Addendum Number 3
24-18-211863 Warehouse Heating System Upgrade
Closing Date: 03/27/2024

Please see attached revised electrical drawings. These address changes to power and circuiting for radiant heaters. Should vendors need more time to produce a bid, please advise in writing by Monday, March 25, 2024 at 1:00 P.M.

PROJECT: **ALASKA RAILROAD CORPORATION
WAREHOUSE #1 HEATING RENOVATION**

TITLE: **ELECTRICAL LEGEND AND SCHEDULES**

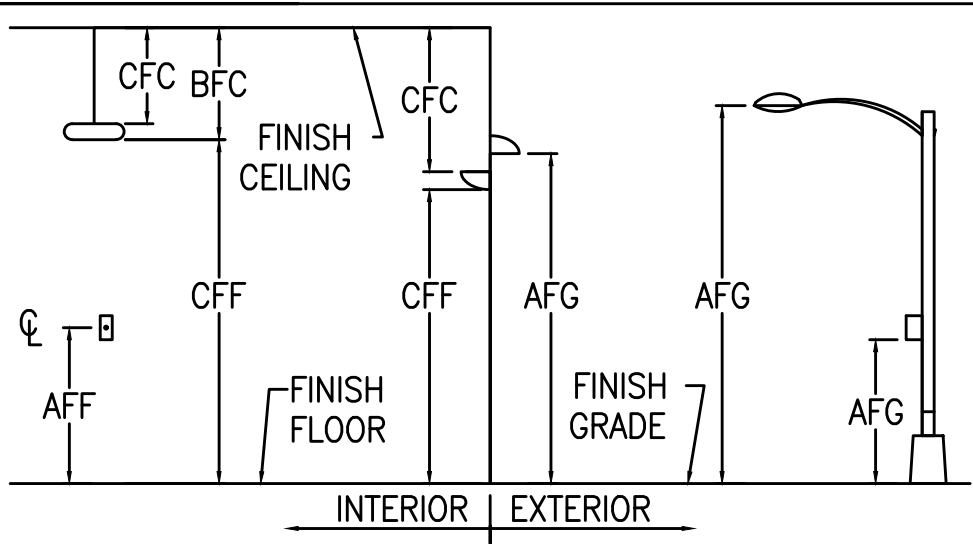
- EXISTING BREAKER MARKED AS SPARE TO BE USED FOR NEW LOAD. FIELD VERIFY AVAILABILITY PRIOR TO CONNECTION.
- DEMOLISH SPARE 20A/1P BREAKERS. PROVIDE NEW 20A/2P BREAKER FOR VACUUM PUMP.

1 ELECTRICAL PLAN
E3.1 SCALE = 1/8" = 1'-0"

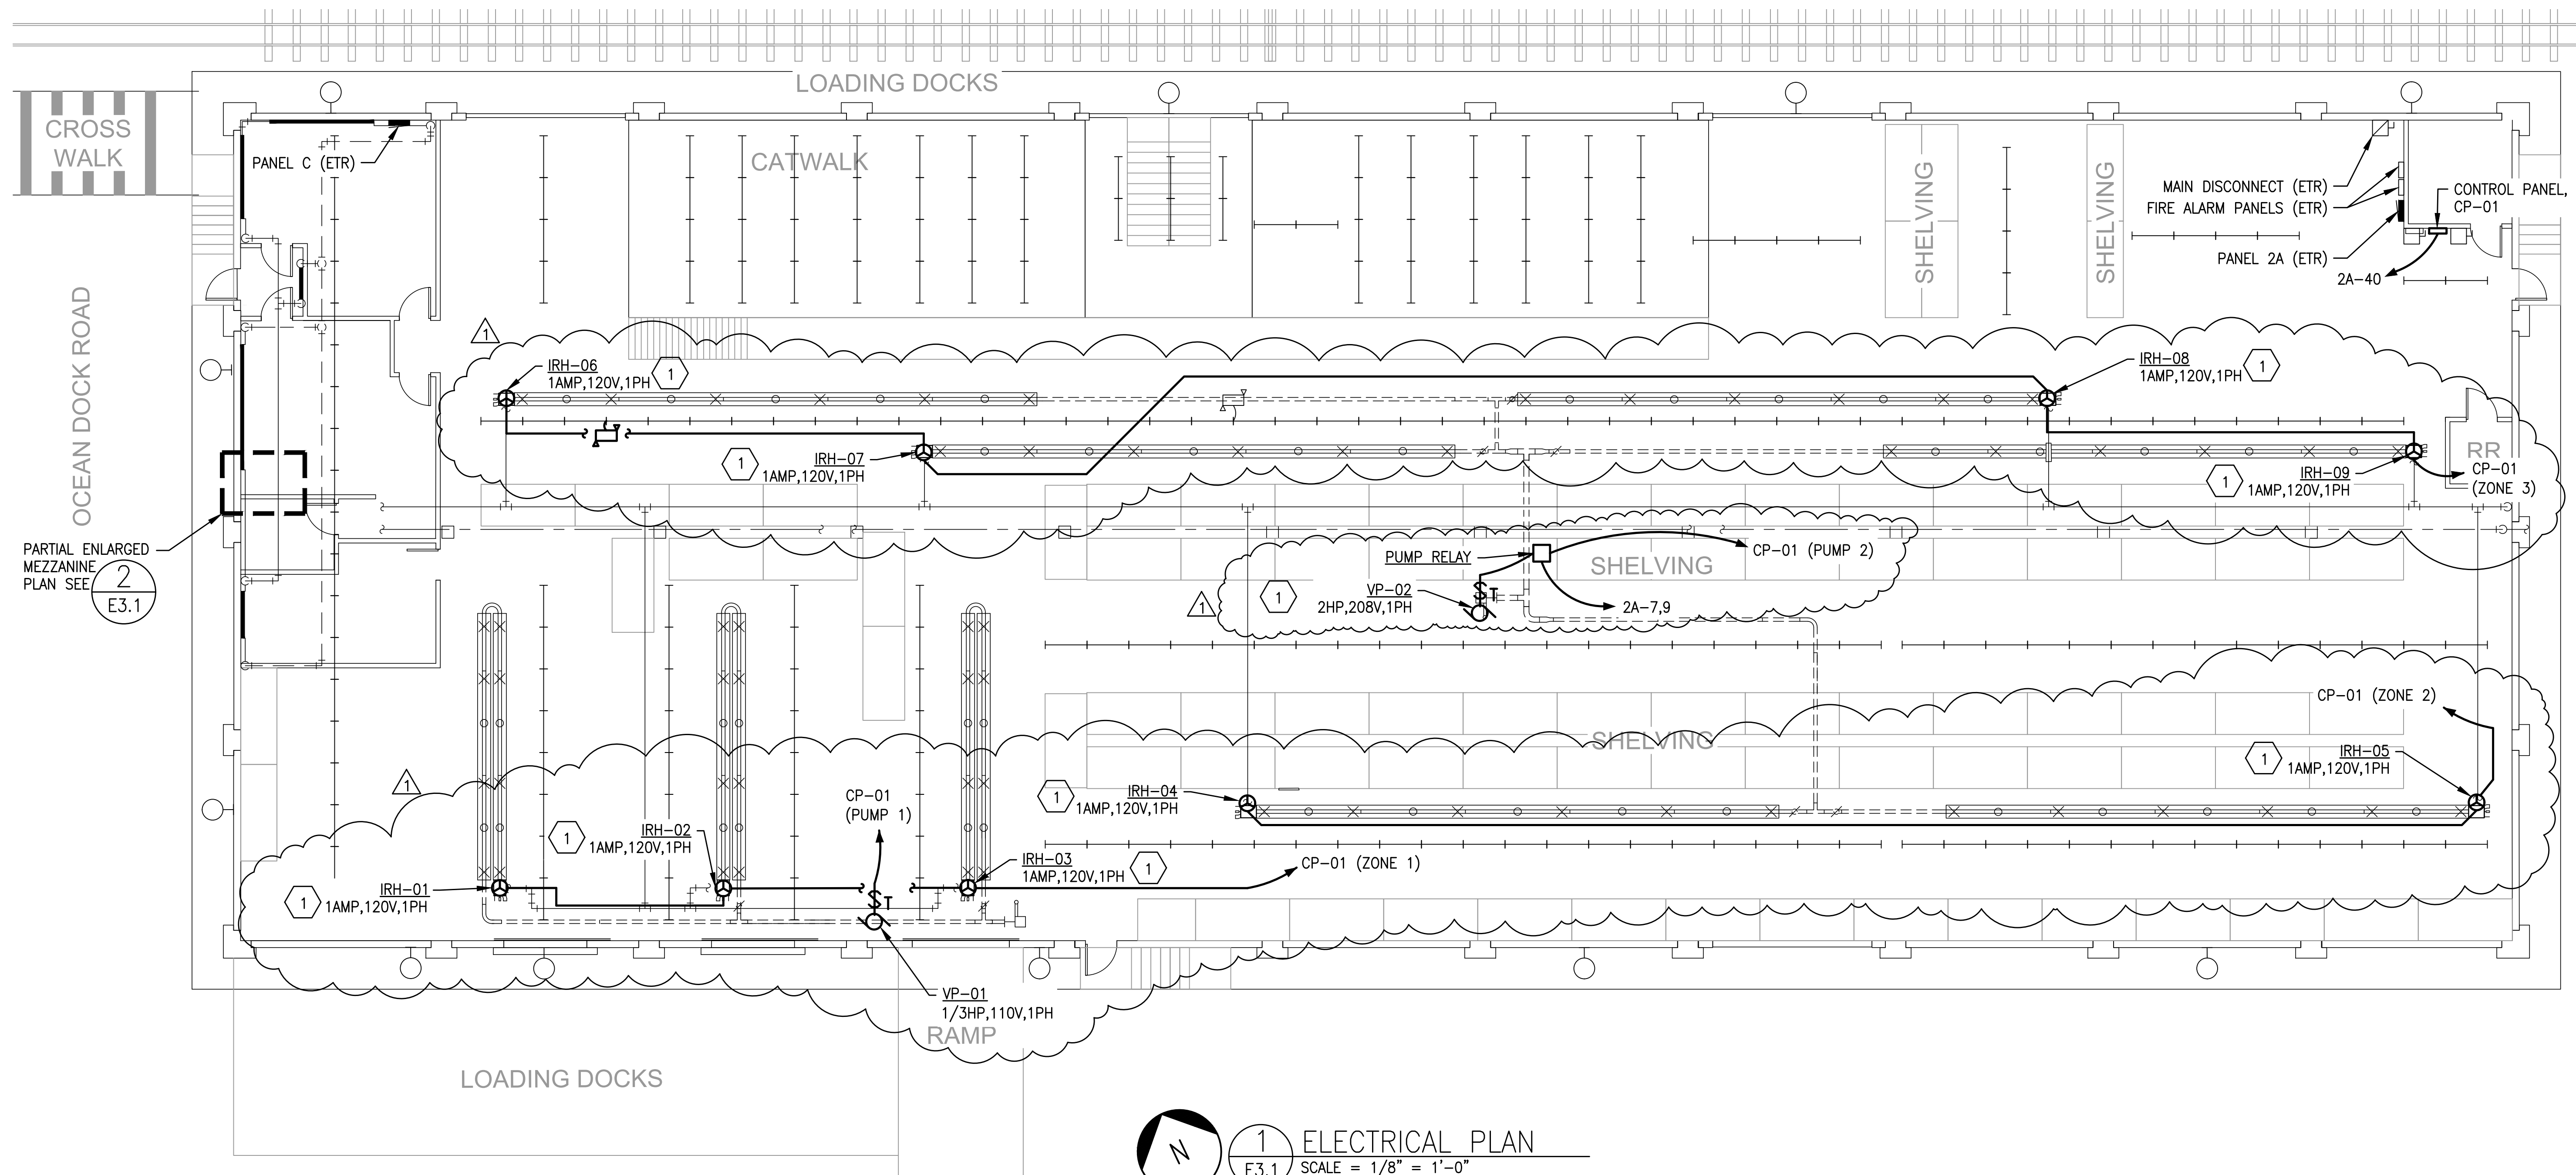
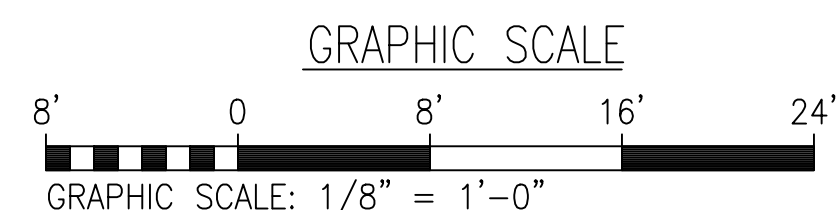
- 1 INSTALL RADIANT HEATER CONTROLS AND SAFETIES IN ACCORDANCE WITH MANUFACTURERS INSTRUCTIONS. CONNECT TO CIRCUIT INDICATED.
- 2 PROVIDE 1/2" C, 2#12, 1#12 GND TO AVAILABLE POLE SPACE IN PANEL 'C'. REUSE EXISTING IF PRACTICAL OR PROVIDE NEW 20A/1P BREAKER LISTED FOR USE IN EXISTING PANEL AS REQUIRED FOR NEW LOAD.
